HISTORIC
STARKVILLE
MISSISSIPPI'S COLLEGE TOWN
THE CITY OF STARKVILLE
DEVELOPMENT REVIEW COMMITTEE
CITY HALL, 101 E. LAMPKIN STREET
STARKVILLE, MISSISSIPPI 39759

SUBJECT: Starkville Tree Advisory Board
DATE/TIME/PLACE: MAY 6, 2015, 11:00 AM, CITY HALL CONFERENCE ROOM

TO: Members of the Tree Advisory Board
FROM: Daniel Havelin (662-323-2525 ext. 136)
SUBJECT: LW 15-02 Ergon Properties, Landscape Waiver, Mercantile Street, Zoned T6, Ward 4, Seeking relief from the requirement to have 1 canopy tree per landscape island, Applicant/ Owner: Ergon Properties, Inc./ Jim Defoe
DATE: May 6, 2015

TO: Members of the Tree Advisory Board
FROM: Daniel Havelin (662-323-2525 ext. 136)
SUBJECT: LW 15-03 Starkville Apartments LLC, Landscape Waiver, Southeast corner of Russell Street and Spring Street, Zoned T-5, Ward 4, Seeking relief from the requirement for landscaped perimeter of parking area, Applicant: Christian Preus Landscape Architecture, PLLC, Owner: Starkville Apartments, LLC
DATE: May 6, 2015

**MERCANTILE STREET
PARKING ISLANDS**
24 April, 2015

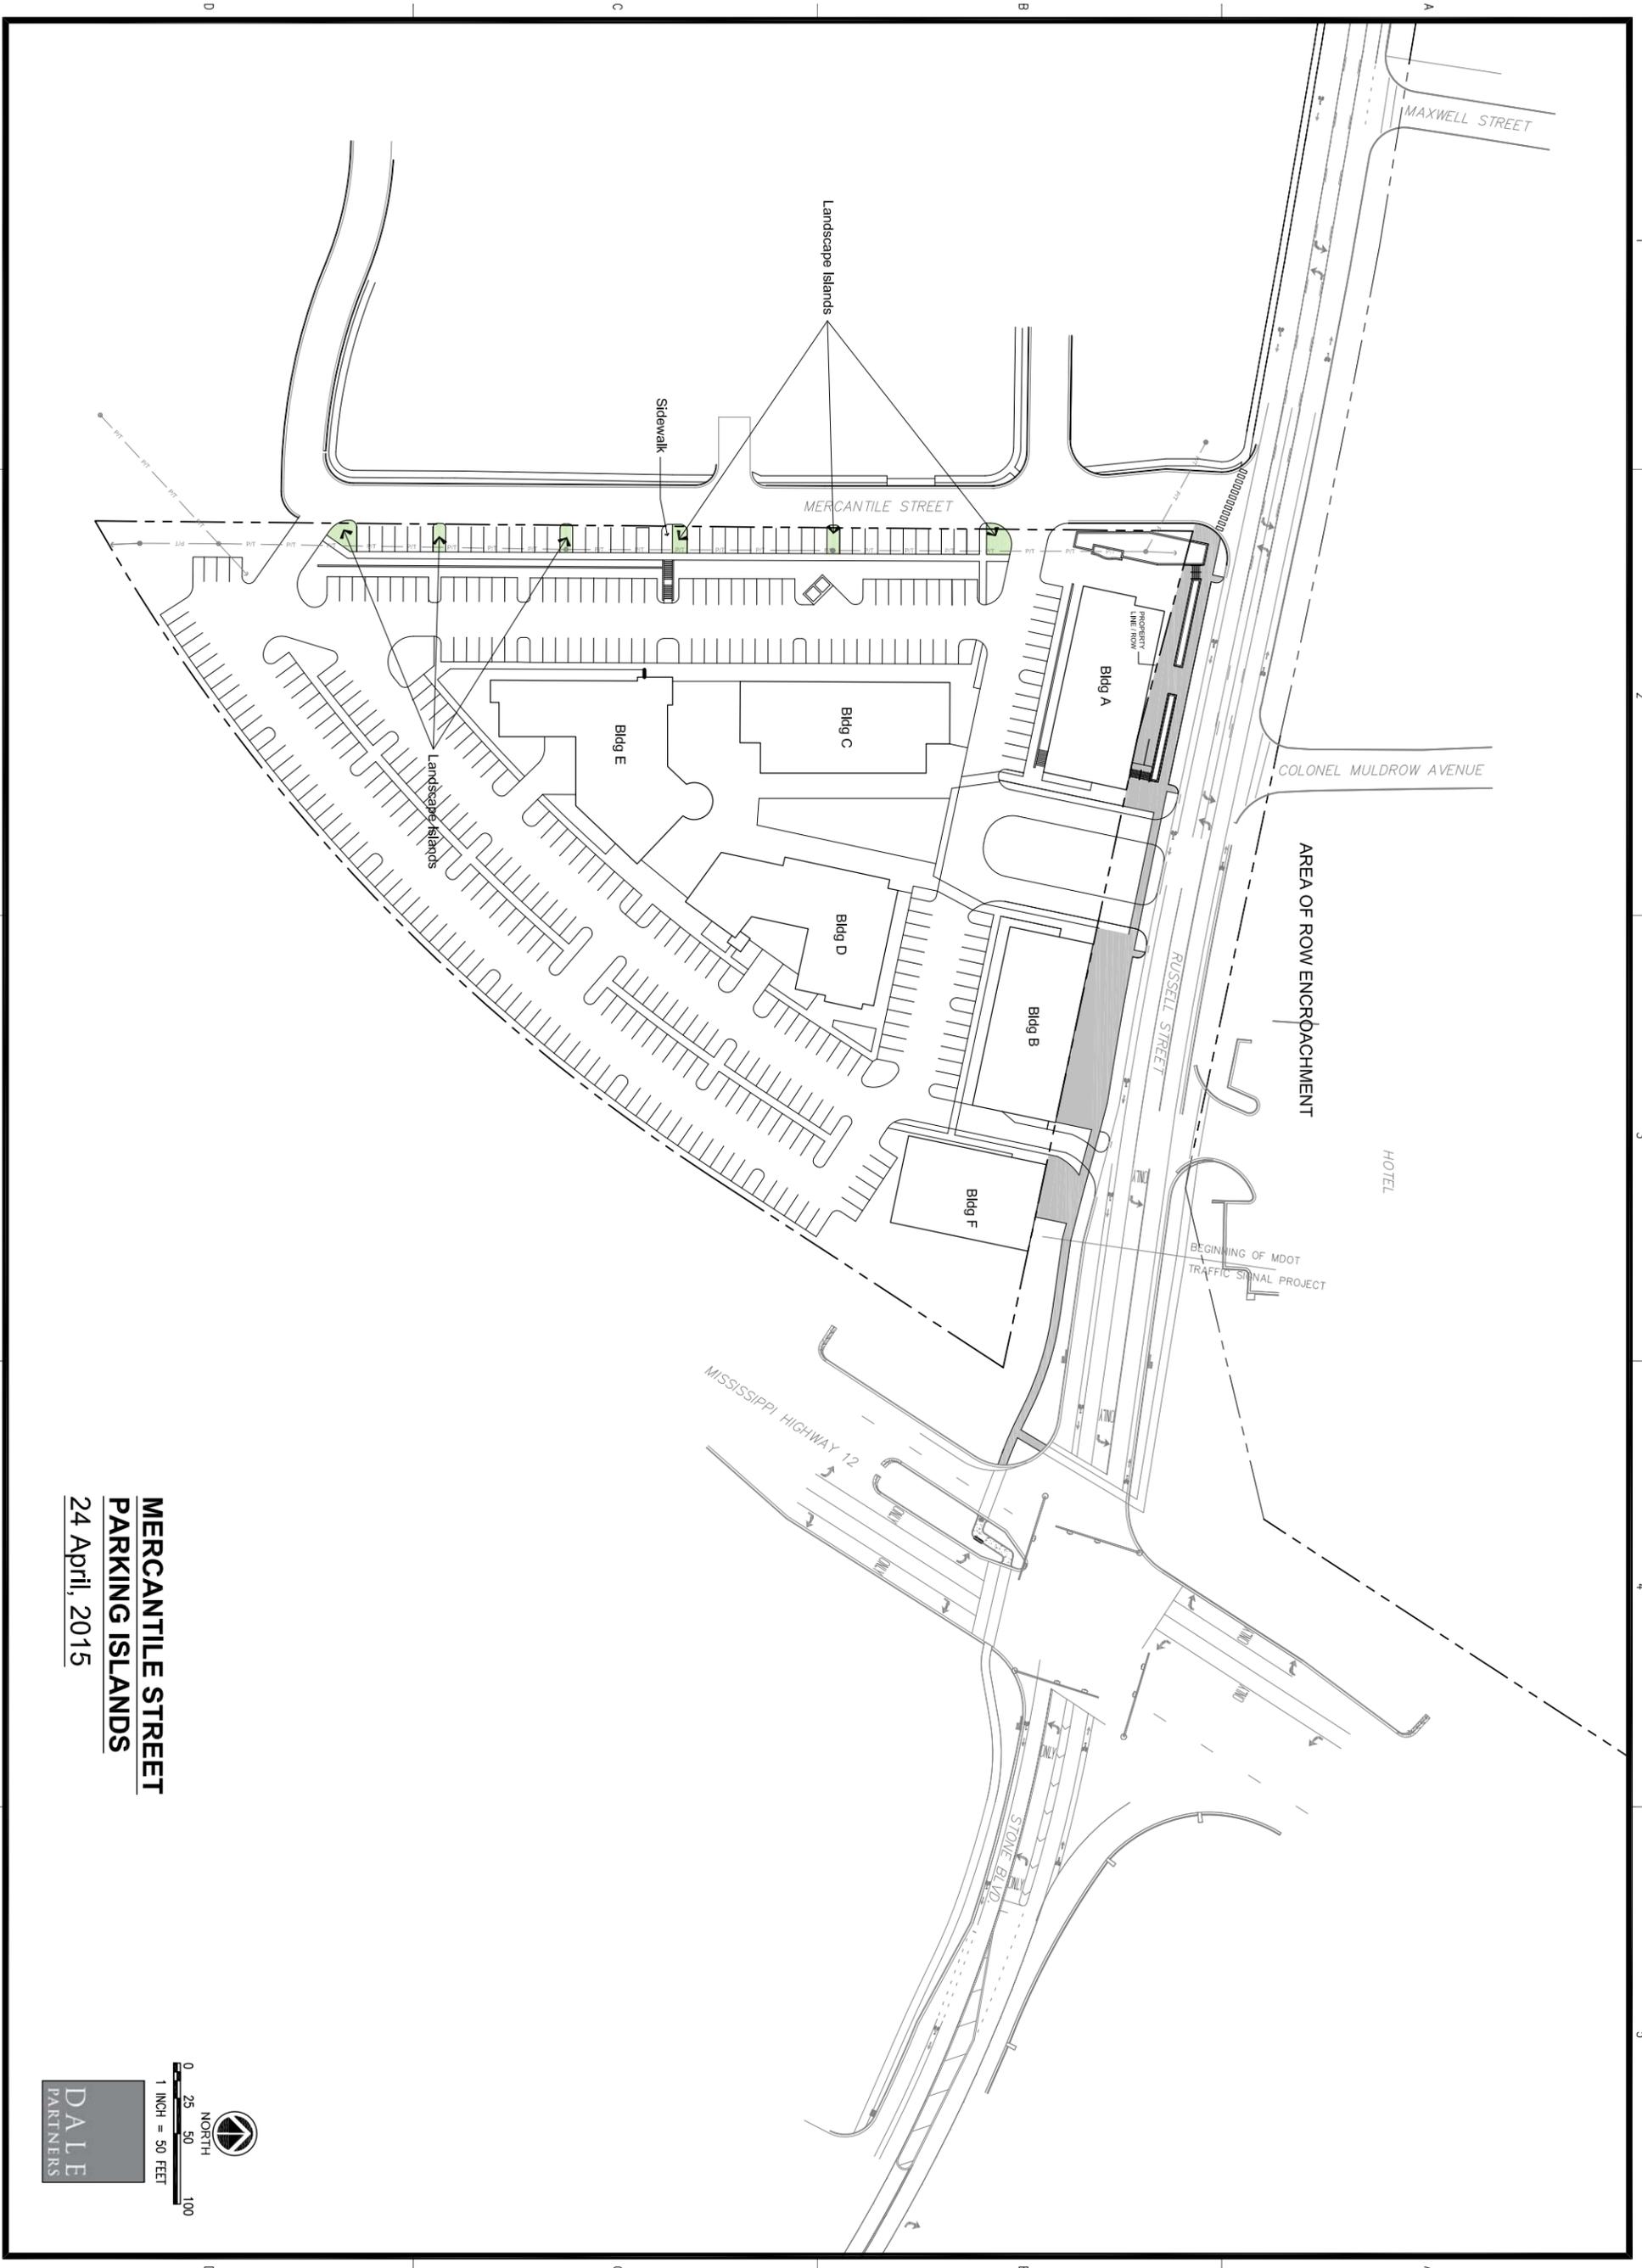
Ergon Properties is proposing to build a large scale multiuse development at the southeast corner of Russell Street and Mercantile Street. This site is approximately +/- 6.17 acre and is zoned T-6. The applicant is proposing on-street parking along Mercantile Street. The current plans do have landscape island spaced no more than 12 spaces apart. Due to the existing overhead power lines, the applicant is seeking relief on having one canopy tree per Landscape Island.

- According to Part A of Section 6, One tree is required for each 200 square feet of required landscape area (in this case the parking lot islands). Due to overhead power, Applicant is seeking relief from the canopy requirement in this area.
